**PLANNED UNIT DEVELOPMENT
& SUBDIVISION STAFF REPORT****Date: November 6, 2008**

DEVELOPMENT NAME Grant Park Subdivision, Resubdivision of Lots 16 & 17

CONTEMPLATED USE 1-lot, residential subdivision, and Planned Unit Development Approval to amend a previously approved Planned Unit Development Approval to allow reduced lot sizes, reduced building setbacks, and increased site coverage in a residential subdivision.

SITE PLAN

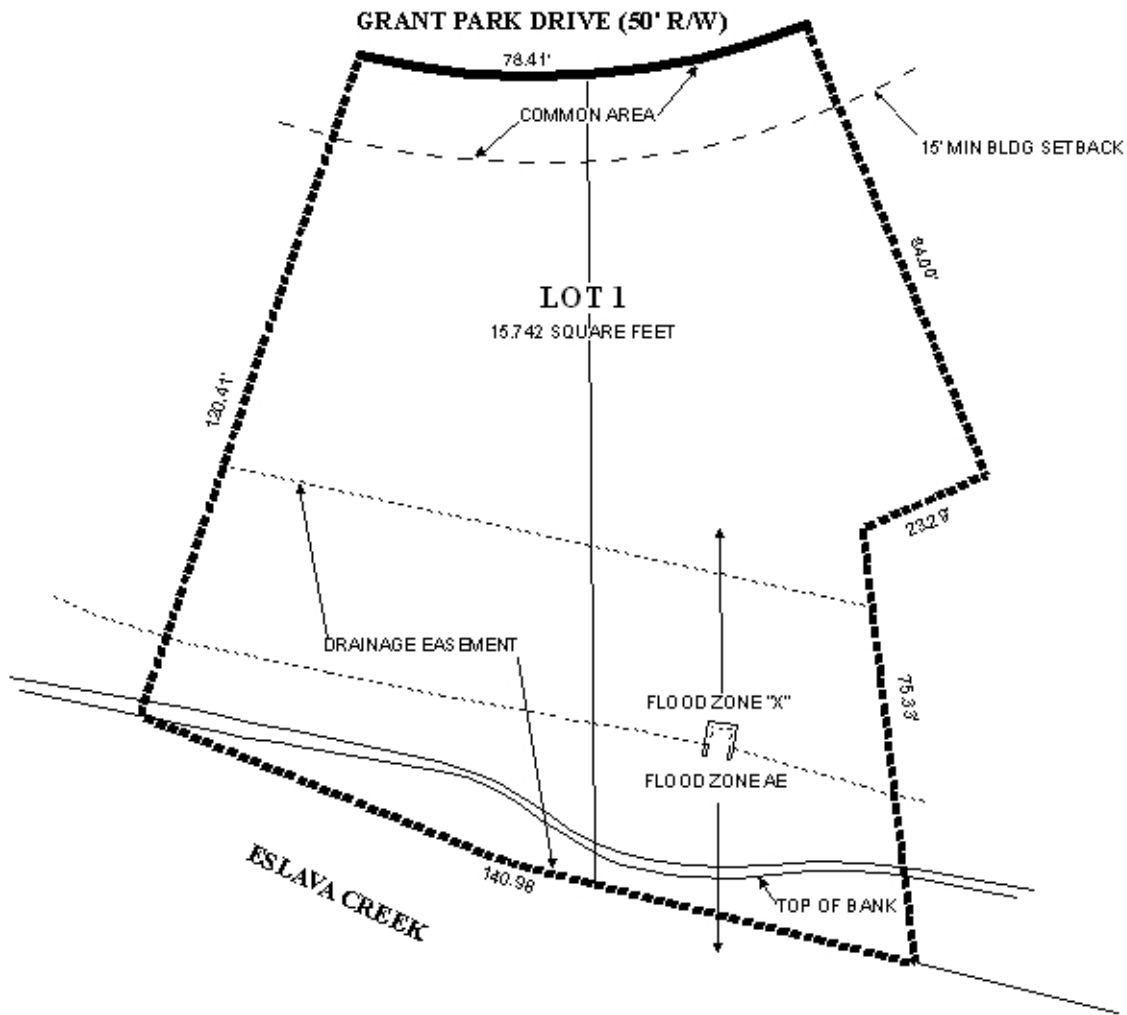
The existing PUD allows a 15' front yard setback, 0' East side yard setback, 5' West side yard setback, and an 8' rear yard setback. Like the original PUD and subdivision, these applications contain notes stating that there must be a minimum of 10' between buildings. These setbacks are graphically depicted on the preliminary plat and proposed site plan, however, they should also be noted in writing on the preliminary plat and proposed site plan, to ensure conformance with the existing PUD. The typical lot diagram should be revised to reverse the side yard setbacks to match those of the other developed lots along the South and East sides of Grant Park Drive. The PUD should also be revised to add a note which states that HVAC equipment and emergency generators 3' high or higher must meet the yard setback requirements.

The applicant also proposes to combine two existing lots into one 15,742 square-foot lot. Lot widths within the subdivision vary, thus the proposed lot would not be inconsistent or incompatible with the remaining lots. It should be noted that the proposed PUD site coverage amendment for this new lot would allow development with a total ground floor area of 7,084 square feet. As in the PUD, the typical lot diagram should be revised to reverse the side yard setbacks to match those of the other developed lots along the South and East sides of Grant Park Drive, and a note should be added which states that HVAC equipment and emergency generators 3' high or higher must meet the yard setback requirements.

- 4) revision of the typical lot diagram to reverse the side yard setbacks to conform to other developed lots on the South and East sides of Grant Park Drive;

- 4) revision of the typical lot diagram to reverse the side yard setbacks to conform to other developed lots on the South and East sides of Grant Park Drive;

- 1) completion of the Subdivision process;
- 2) placement of a note on the site plan specifying the front, side and rear yard setbacks;
- 3) placement of a note on the site plan stating that the site is limited to a maximum 45% total site coverage, subject to verification by the Engineering Department that existing stormwater facilities are adequate for the increase;

- 5) placement of a note on the site plan stating that HVAC equipment and emergency generators 3' high or higher must meet setback requirements;
- 6) placement of a note on the site plan stating that common areas are to be maintained by the property owners;

- 7) placement of a note on the site plan stating that two over-story trees are to be planted within the 25' frontage of the lot along Grant Park Drive;

- 1) provision of two (2) revised PUD site plans to the Planning Section of Urban Development prior to the signing of the Subdivision plat;
- 2) placement of a note on the plat specifying the front, side and rear yard setbacks;

- 3) placement of a note on the plat stating that the lot is limited to a maximum 45% total site coverage, subject to verification by the Engineering Department that existing stormwater facilities are adequate for the increase;
